STRAWBERRY PARK RESIDENCE
STEAMBOAT SPRINGS
COLORADO

PLAN REVIEW COMMENTS

Job Address: tbd
Applicant: PF Wall, LLC.

Plan Log No. CB-06-438
Designer: CCA

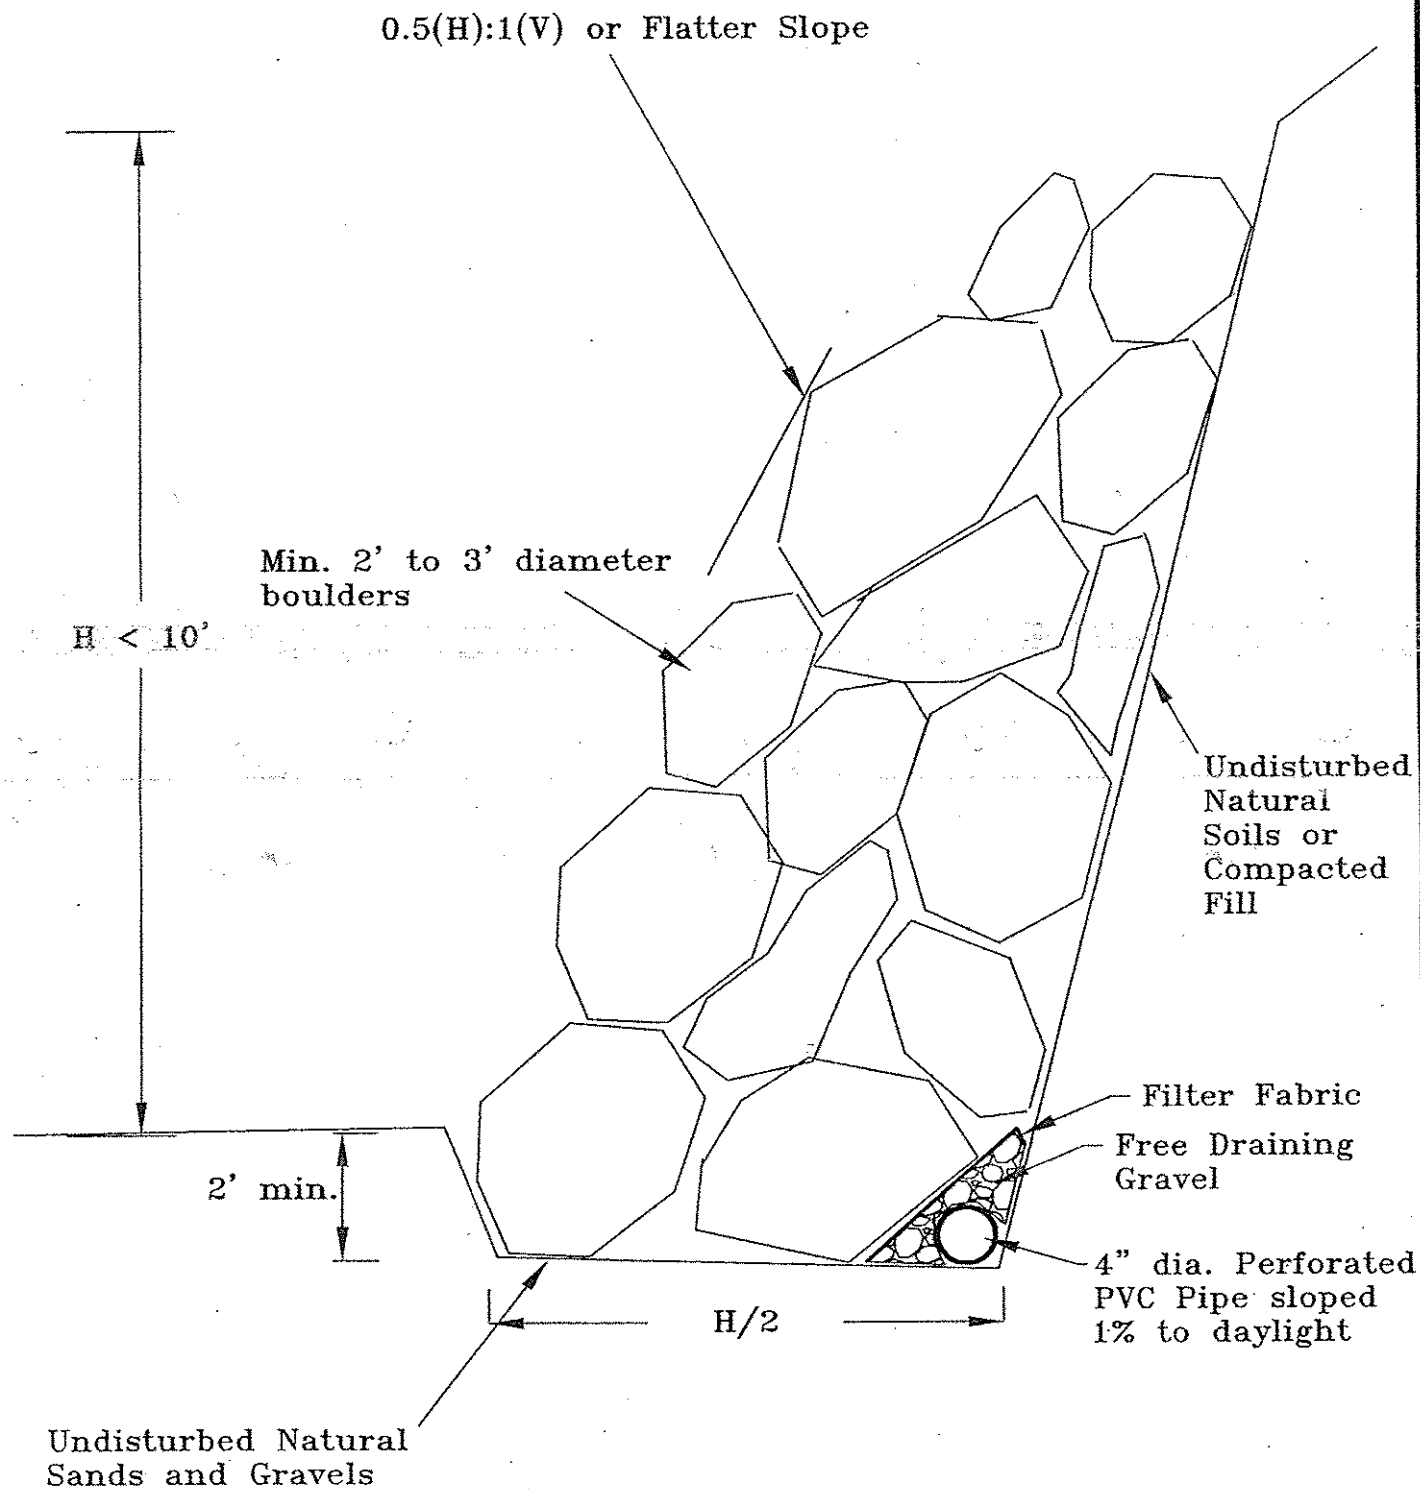
1. Remove the words "Foundation only" for a full permit.
2. Provide an engineered design for retaining walls greater than 4' high. 8/S2.
3. Show how you will provide supply air to the media room.

wall cross section is shown in the attached Figure #1. Proper surface drainage should be provided around all of the finished slopes to direct surface and subsurface runoff away from the walls.

5 EXT. GUARD RAIL
1 1/2" = 1'-0"

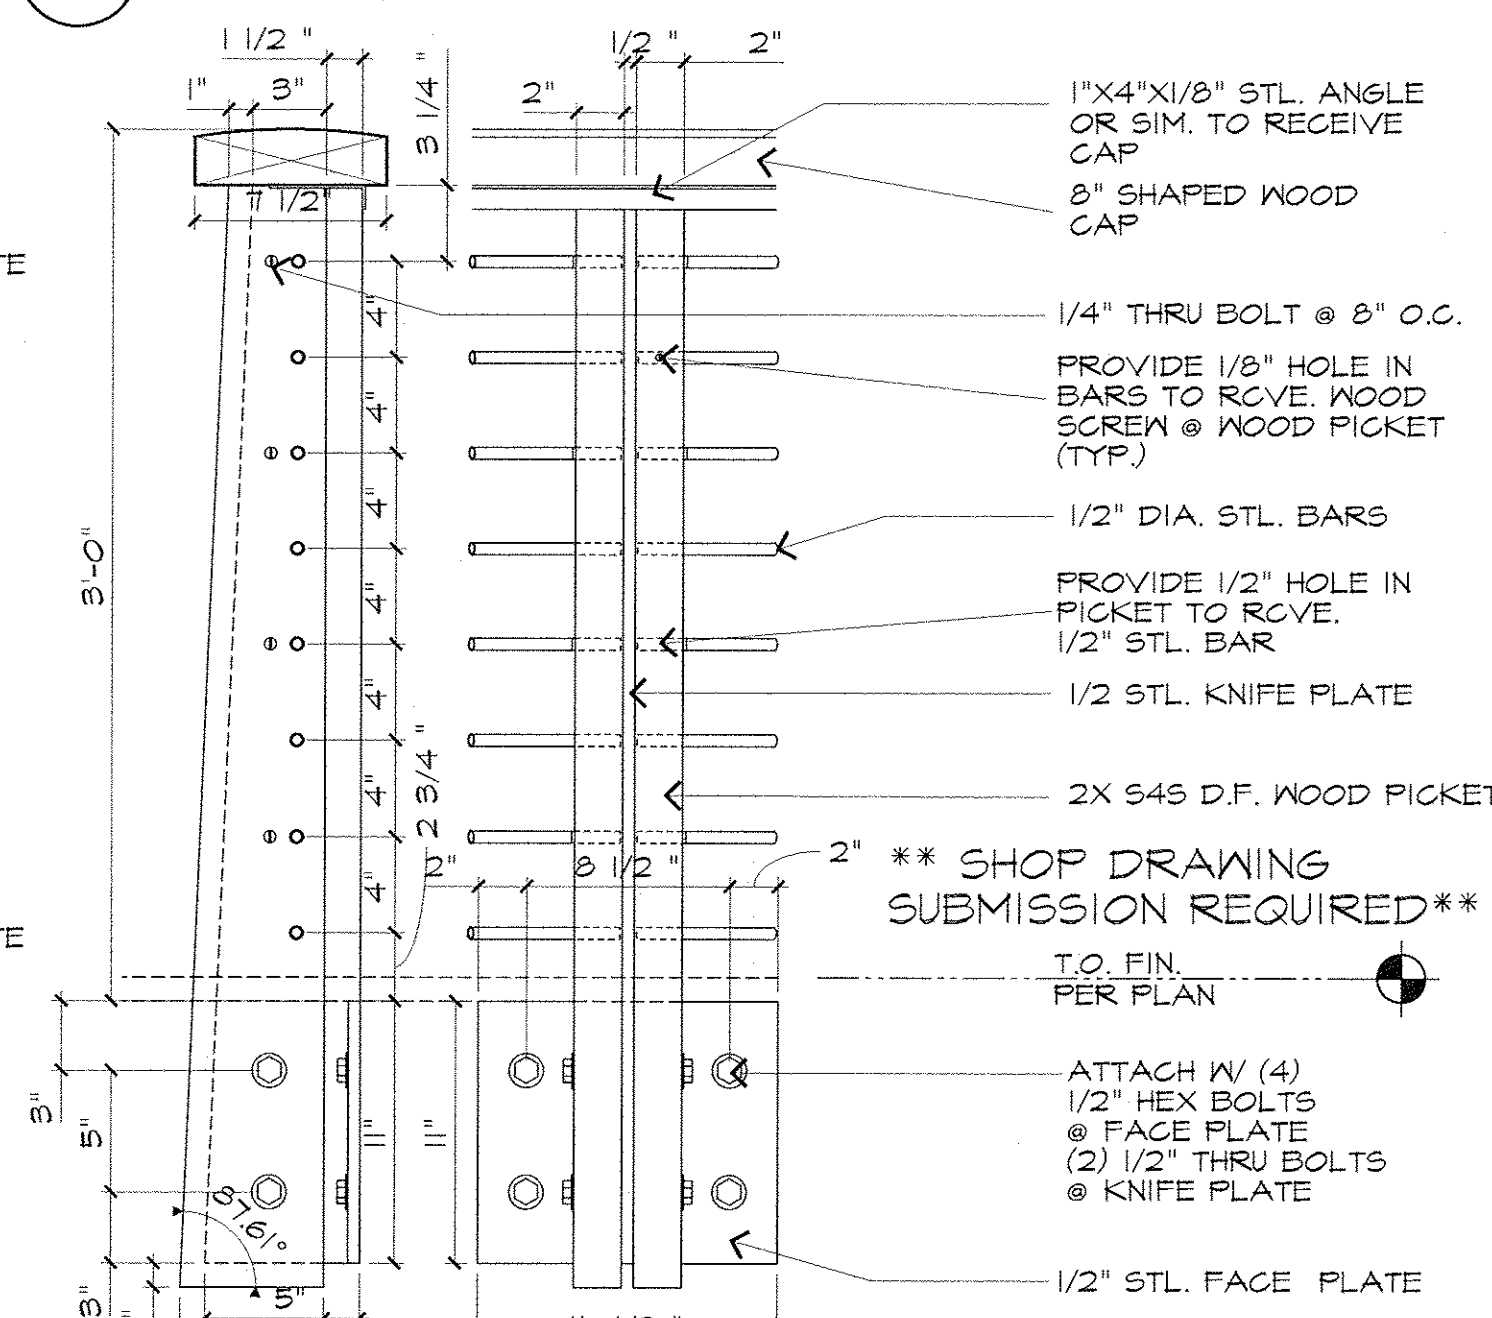
4. Provide a complete concrete fireplace design. See R1003. Show how you will comply with R1003.9, .10, .11, R1005.
5. Show how you will comply with "cablerail specifications". 5 & 12/A9.2 and 5 & 12/A9.3. Guardrails from aircraft cables Documentation from a manufacturer of cable guardrail explains that the cables must be installed at a spacing closer than that required by the UBC. The published installation instructions from this manufacturer show a maximum post spacing of 4.5 feet with a vertical spacer midway between the posts to hold the cables in line and prevent deflection of the wire. The maximum spacing of the cable is 3 inches o/c.

1. Foundation Only has been removed from the full set of structural drawings issued for full permit.
2. A retaining wall design for walls up to 10 feet has been provided.
3. A note has been added to the plans stating that the media room will receive light and ventilation per code minimums via artificial light and a HRV.
4. The fireplace specified is 5 piece modular conc. unit manufactured by Contempo Fireplaces, Alb, NM—A cut sheet, install manual and manufacturer details are contained in this document. (attached)
5. Manufacturer specs have been attached for the cable rails and details in plan set now reference this Manufacturer.
6. See item 4.
7. Complete structural drawings have been provided.
